ITEM 4. DEVELOPMENT APPLICATION: 286-296 SUSSEX STREET SYDNEY

FILE NO: D/2014/755

SUMMARY

Proposal Summary: The proposal (as amended) seeks consent for a Stage 1 concept proposal, including the following:

Figure 14: The building envelope, as originally lodged in May 2014

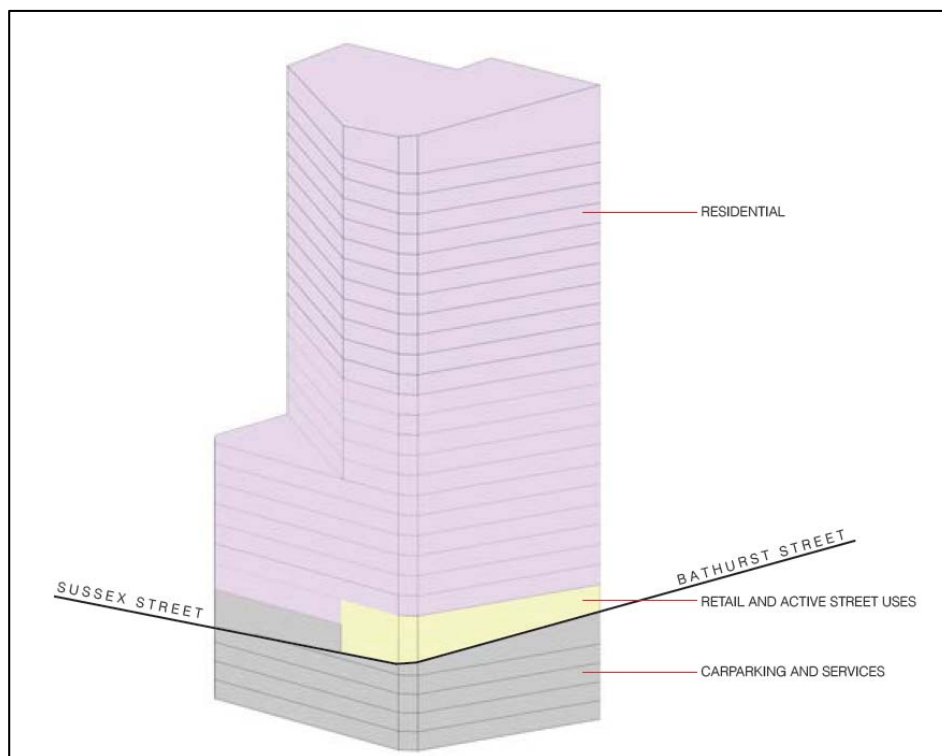
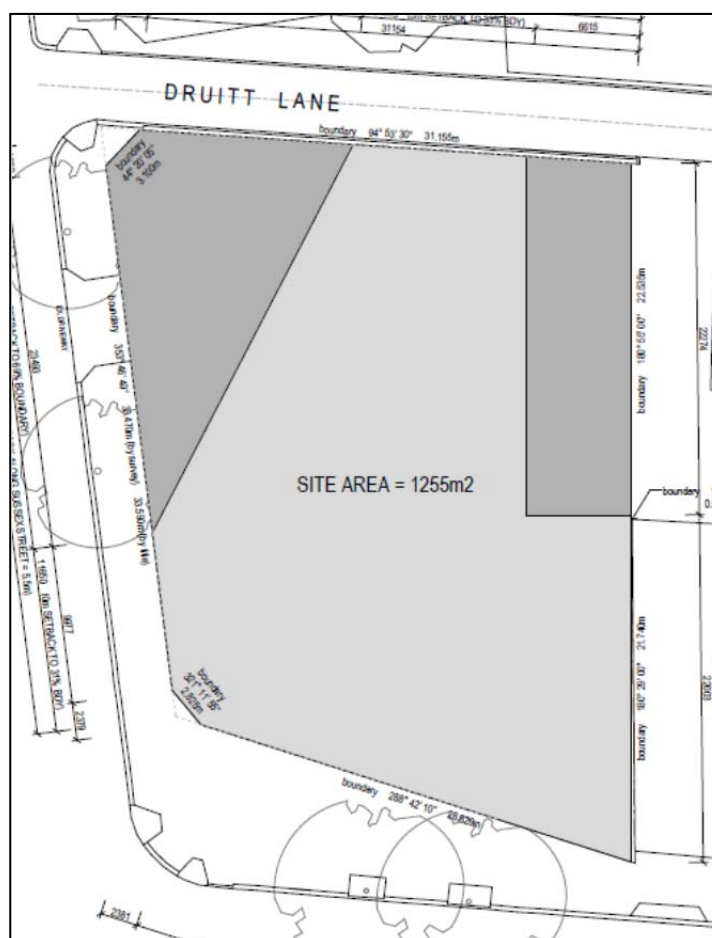
14. Following a preliminary assessment of the application, including consideration of the matter by the City's Design Advisory Panel, the Applicant was advised in correspondence, dated 1 October 2014, that the proposal was not supported in its current form.

- (d) **Overshadowing** – Preliminary assessment of the proposal noted that the proposed envelope cast additional shadowing on the existing residential apartment buildings to the south of the site (on the opposite side of Bathurst Street). In addition to the modifications sought to the envelope, it was requested that further shadowing analysis be undertaken to ensure that any new shadowing does not reduce the level of solar access below 2 hours of solar access on the winter solstice;

- (a) a change in land use for the podium of the building (Ground floor to Level 8) from residential to hotel;
 - (b) provision of a 6-metre setback of the tower from Bathurst Street;

- (e) amended indicative floor plans to illustrate the ability of the envelope to accommodate a DCP compliant unit mix and greater compliance with the principles of SEPP 65/RFDC.

Figure 16: Proposed separation distances achieved across DrUITT Lane

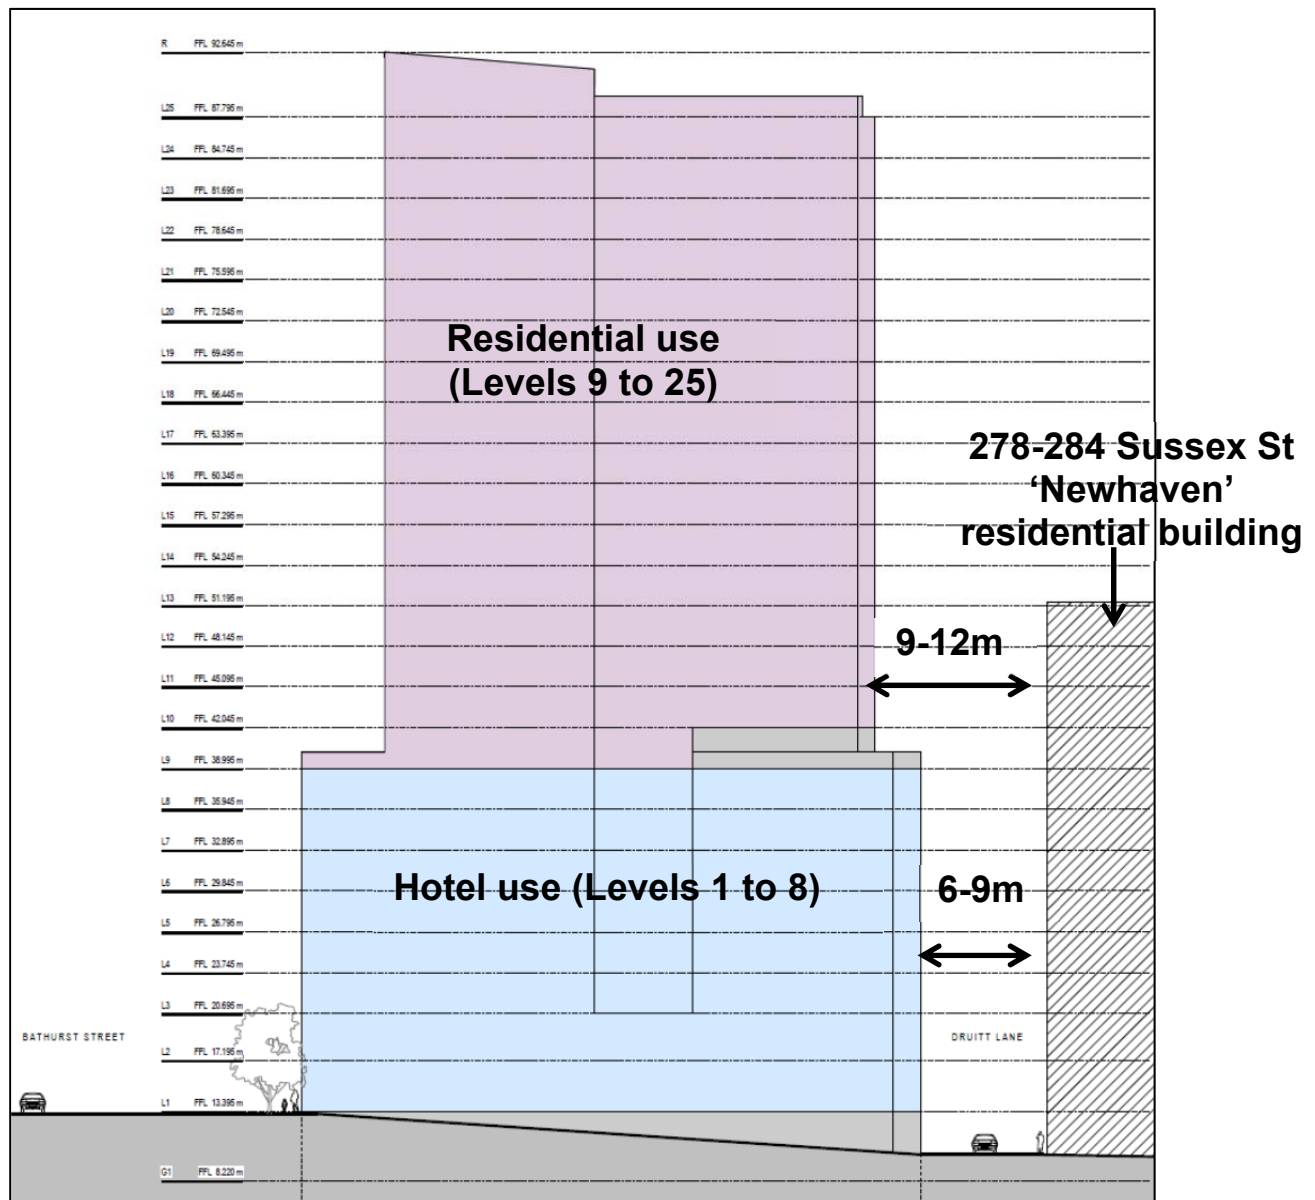
46. As detailed in **Figure 16**, below, the podium (ground to Level 8) of the subject development is proposed to have a nil setback along the northern boundary of the site to Druitt Lane. This equates to a separation between the future hotel use in the podium of the proposed development and the existing residential building to the north, known as 'Newhaven' (278-284 Sussex Street), of between 6 to 9 metres.

49. In this instance, a separation of 7 to 9 metres is achieved from the proposed northern wall of the podium to the south facing windows of the Newhaven building (located on the opposite side of Druitt Lane). A review of the floor plans of the Newhaven building has revealed that the windows that are directly oriented south to front the lane are bedroom windows and not the principal living windows of these apartments.

50. Where the separation between the buildings is reduced to a minimum of 6 metres, this is limited to two locations along the facade, as illustrated on **Figures 17 and 18**, below, with these being to a blank side wall and the other to the side elevation of a balcony.

51. In this instance, the separation distances across the lane (for the podium levels) is considered to be adequate as:
 - (a) There is only one location where an area of principal open space or living room would not be separated from a commercial use by the desired separation of 9 metres. It is noted that both the living room windows and its associated balcony are not oriented to the south (towards the site) but rather towards the southwest (i.e. towards Sussex Street);
 - (b) The existing commercial building on site is built to the northern laneway boundary of the site and already contains windows on this northern elevation (as illustrated in **Figure 19**, below). As a hotel is defined as a commercial use, the proposal is not resulting in any greater privacy impacts than the existing situation;

- (c) It is considered that those areas with 6 metre separation could be resolved through skilful design of the detailed internal planning of the future hotel, and through the architectural treatment of the podium through both the competitive design process and the Stage 2 Development Application.

Figure 20: Analysis to illustrate retention of outlook from Newhaven apartments

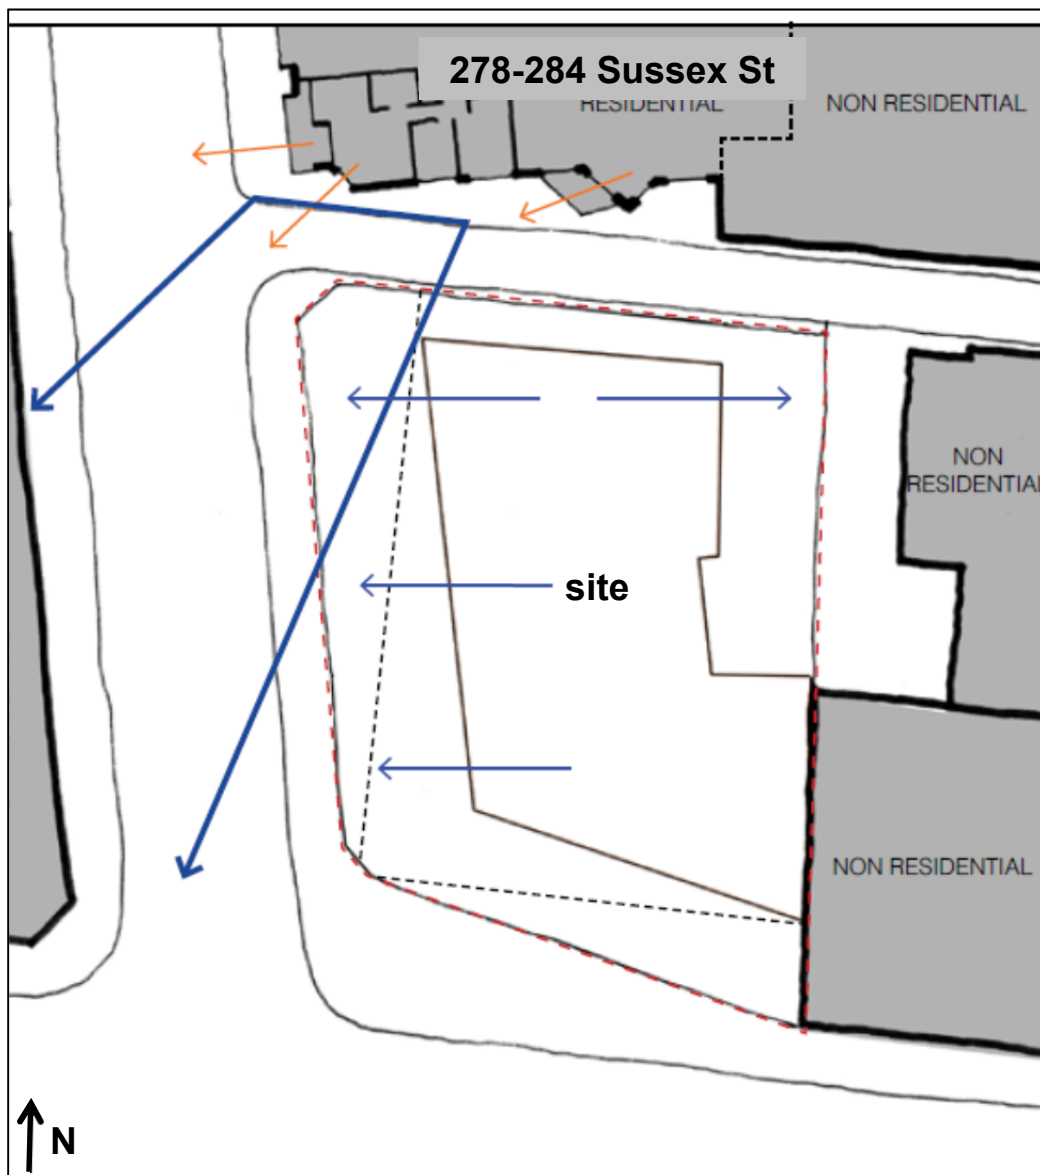
- (d) as is demonstrated in **Figure 20**, below, the width of the future tower on the subject site would limit a maximum of two apartments to this northern face, and it could reasonable be assumed that each of these apartments will be designed so that its oriented to either the east or west, not to the north. Therefore, it is considered that the 4 floors where there is an interface between the buildings across the lane could be skilfully designed to address privacy and overlooking;

- (e) with regard to outlook from the southern apartments within the Newhaven building, as demonstrated at **Figure 20**, below, the siting of the tower envelope on the subject site would not preclude the view and amenity from the principal living areas and open space of these units from being maintained.

Figure 21: Proposed tower setback from the eastern side boundary

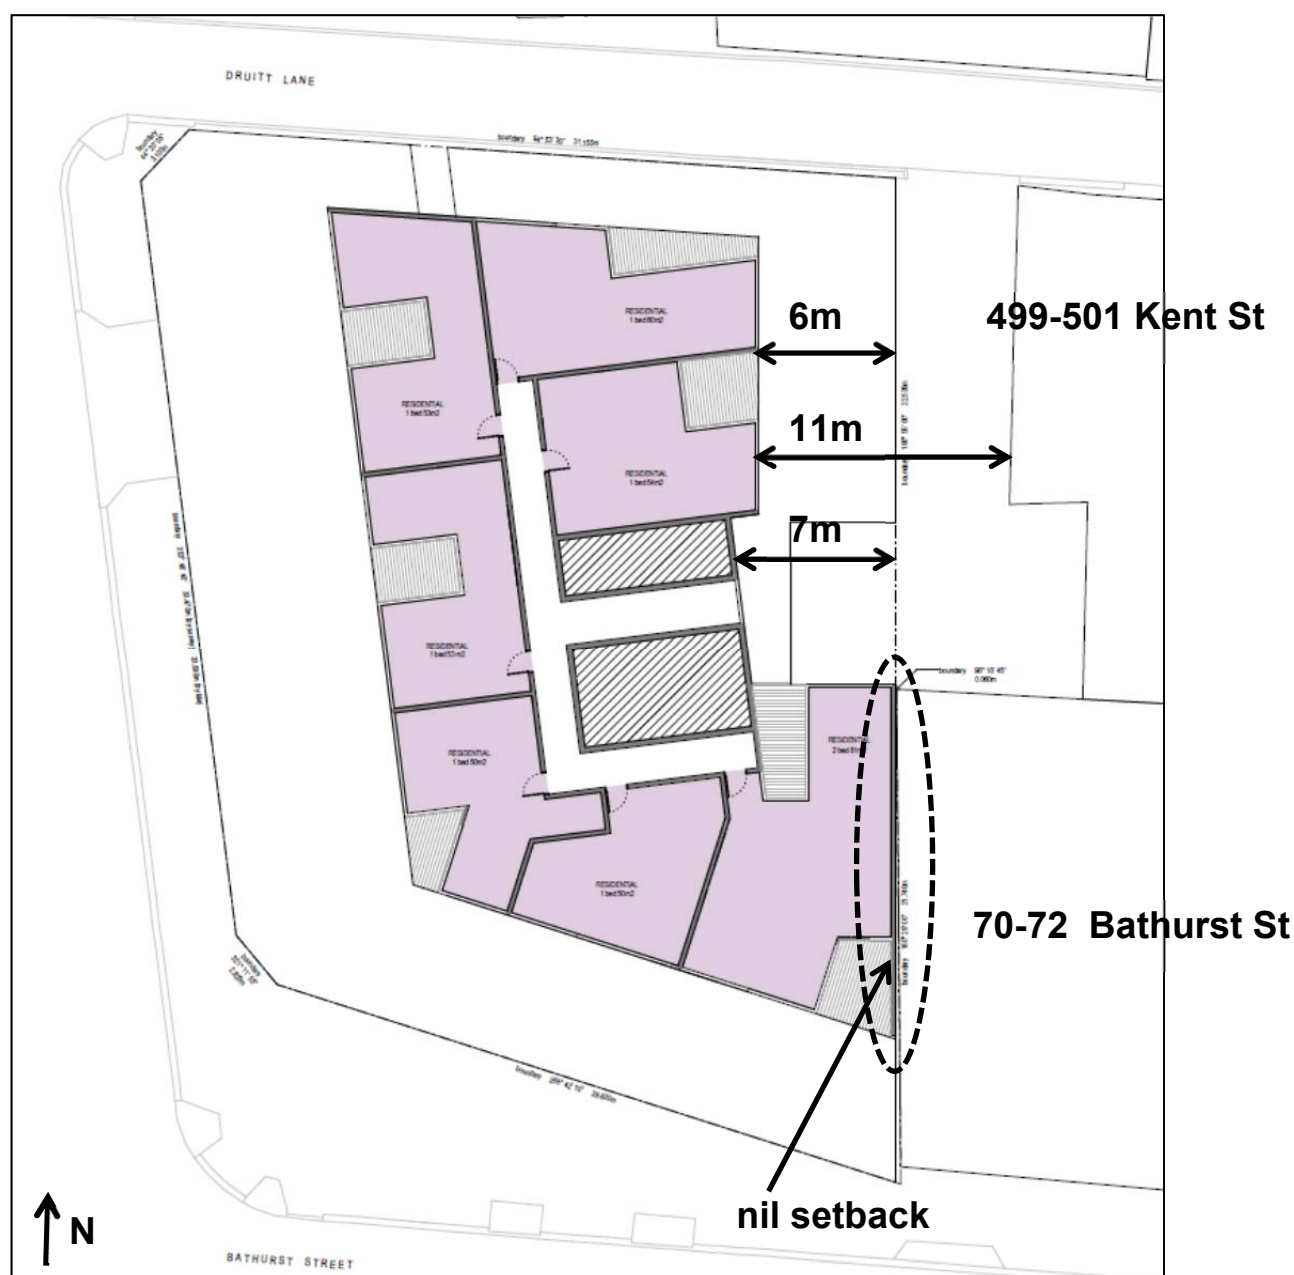
55. The proposed development has been designed with the following setback to the side (eastern) boundary (refer to **Figure 21** below):

- (a) a nil side setback for its podium levels (up to Level 8);
- (b) a variable tower setback (from Levels 9 to 25) between:
 - (i) a nil setback adjacent to its boundary with 70-72 Bathurst Street; and
 - (ii) a 6-7 metre setback adjacent to its boundary with 499-501 Kent Street.

56. With regard to the nil side setback for the podium levels, no objection is raised in this instance to this design, as:
- (a) the podium height will generally align with the existing blank western side wall of the adjacent commercial building at 70-72 Bathurst Street;
 - (b) the existing heritage listed building at 499-501 Kent Street is separated from the proposed podium wall by approximately 5 to 5.5 metres, being the width of the rear cart way of the heritage site. This separation is generally consistent with the 6 metre setback provisions of Section 5.1.2.2 of SDCP 2012 between commercial land uses; and

Figure 22: Northern elevation illustrating the relationship to the adjacent heritage item to the east of the site at 499-501 Kent Street

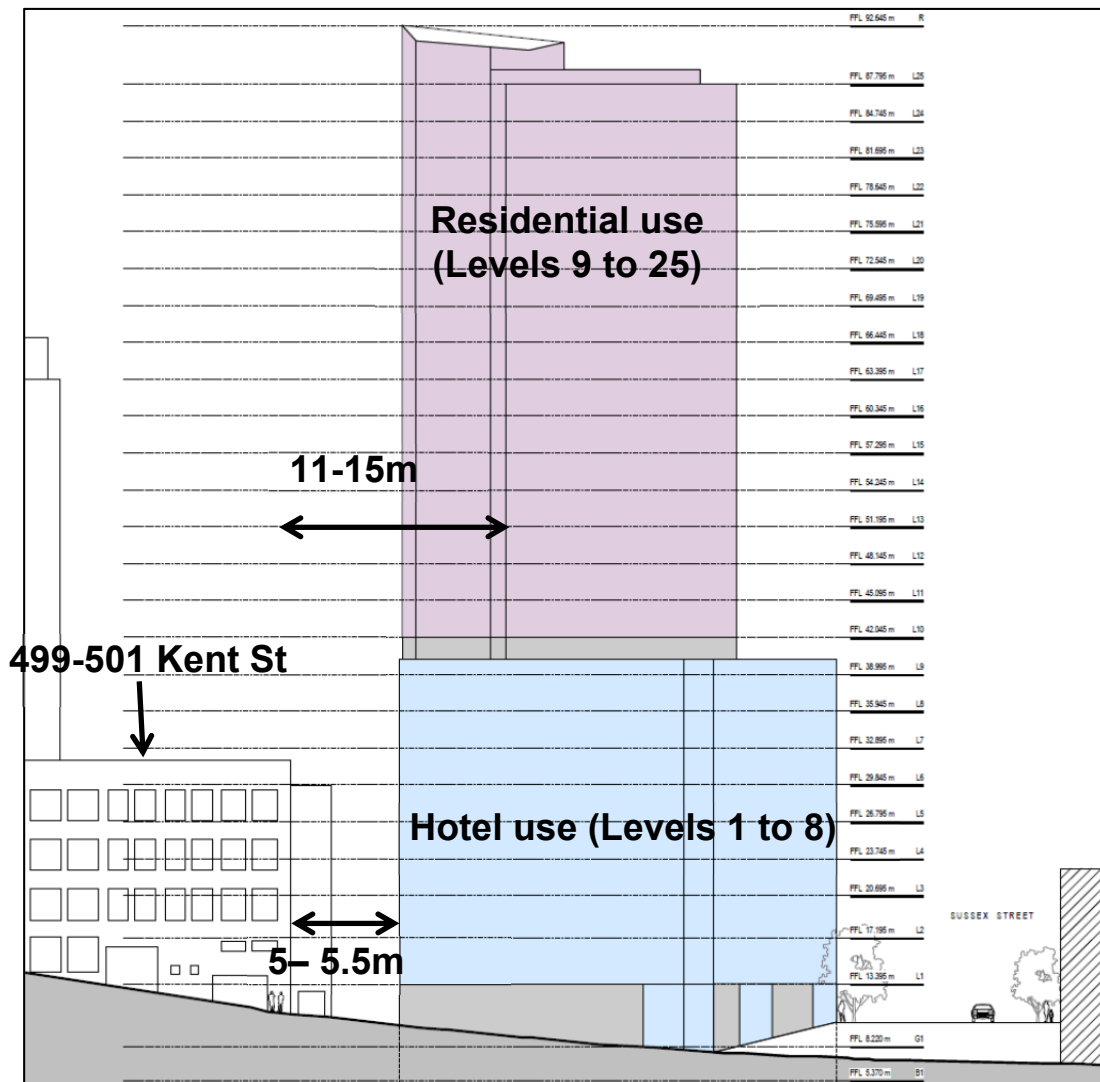
58. As detailed on **Figure 22**, above, a portion of the tower (for a length of 15 metres) is proposed with a nil setback adjacent to the site's side boundary with the commercial building at 70-72 Bathurst Street. The indicative floor plans submitted with the application demonstrate that a blank facade would be presented to the east, and that the future apartment accommodated adjacent to this boundary would be oriented north-south. No objection is raised to the proposed nil setback at this location as it is consistent with the setback provisions of the DCP and does not sterilise the development potential on the adjacent site, which is able to orient any windows in a future tower on its site in a north-south direction.

- (c) noting the above, consideration has been given to whether adequate separation can be achieved. It is considered that a separation of approximately 18 metres could reasonably be achieved between any future towers. This would exceed the separation requirement between a residential and commercial building. In the scenario where each site is redeveloped for residential uses, it is considered that the numeric non-compliance (of 6 metres) could be designed around through internal planning and screening mechanisms.
62. With consideration to the constraints of the site, including siting the tower to respect the contextual podium form, the siting of existing buildings and future redevelopment potential on surrounding sites, it is considered that the proposed envelope is generally compliant with the setback provisions of SDCP 2012 and a satisfactory response to the established built form.

Figure 23: The proposed vehicular access location off Sussex Street

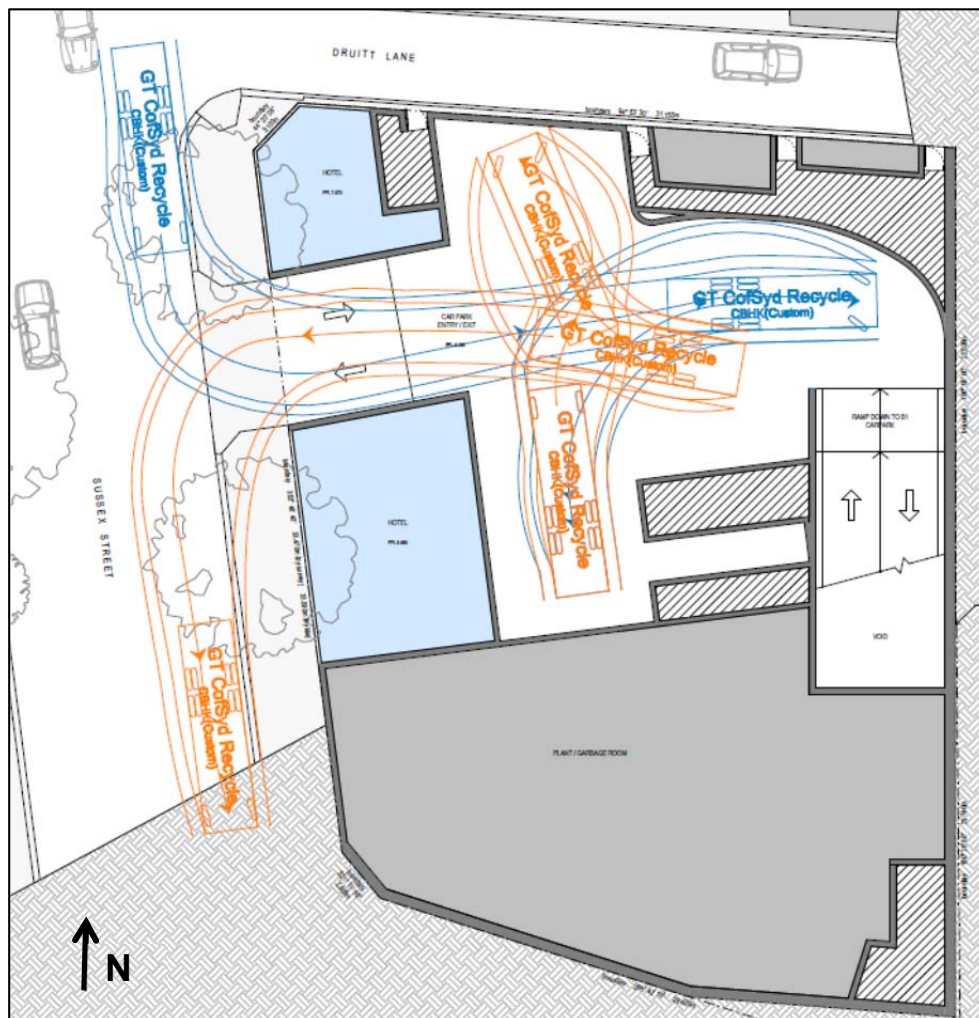
63. The site currently has dual vehicular access locations, one from Druiitt Street and the other from Druiitt Lane. The proposal is seeking to limit vehicular access to the site via a single driveway location on Sussex Street, as illustrated on **Figure 23**, below.

64. Following a preliminary assessment of the application, the Applicant was advised that the City's preference from an urban design, pedestrian safety and traffic point of view, was that vehicular access location for the future building should be relocated to the Druitt Lane frontage of the site. It was advised that consideration may be given to the Sussex Street driveway in the event that sufficient justification was able to be provided to demonstrate that service and waste collection vehicles would be unable to access and service the site via the lane.

66. This additional information has been reviewed by the City's Transport Planner, who has advised that the amended scheme has not adequately explored genuine vehicular access options from Druitt Lane. It has also been noted that the City's garbage trucks already travel along Druitt Lane to service other properties in the vicinity of the site.

- (a) no consent is given to the vehicular access location via Sussex Street as illustrated on the architectural plans; and
 - (b) the design brief for the competitive design process encourage competitors to design a scheme which includes vehicular access via Druitt Lane. This can also allow competitors to give consideration to hotel drop-off and the laneway facade treatment/activation.
